## X/Y table engraver new mirror 1 notice

The change starts from machine serial number [M95211](#).

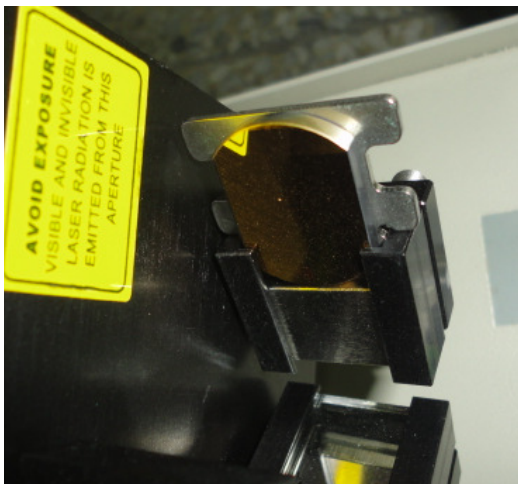
Since the new mirror is circle and easier to produce and maintain, GCC has changed the mirror 1.

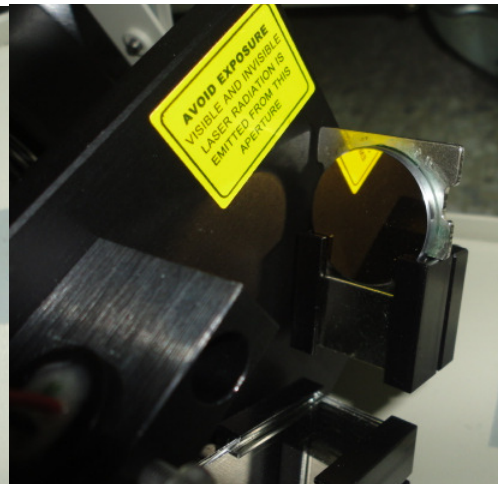
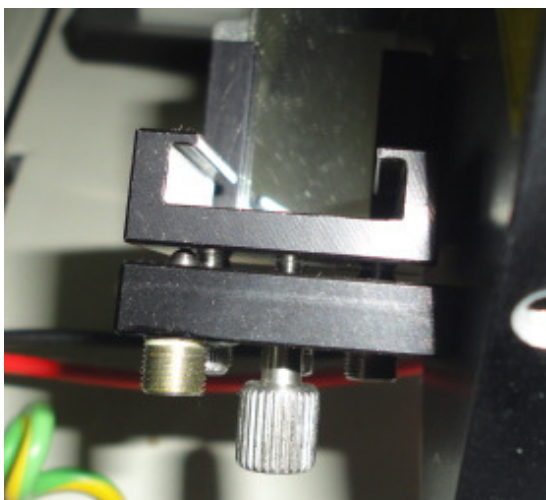
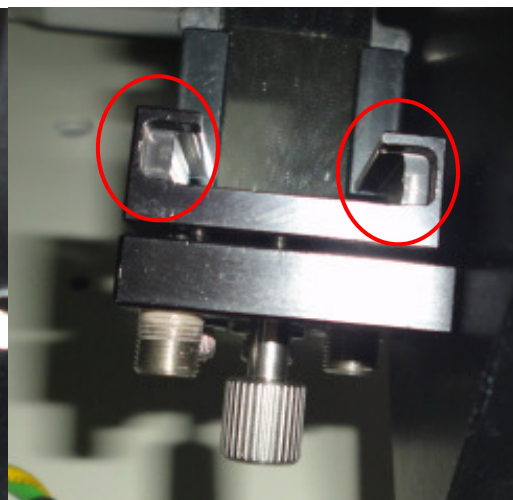
The old and new mirror 1 can put on new mirror 1 bracket, but new mirror 1 cannot put on old mirror 1 bracket.

The old mirror 1 part number: [29003695G](#)

The new mirror 1 part number: [290077670G](#)

**So for machine serial number older than M95211 (or invoice day earlier than August 01, 2013) and customer need to order mirror 1 for replacement, distributors also need to order new mirror 1 bracket for first time.**

The old mirror 1 bracket part number: [20200185G](#)

The new mirror 1 bracket part number: [202003240G](#)
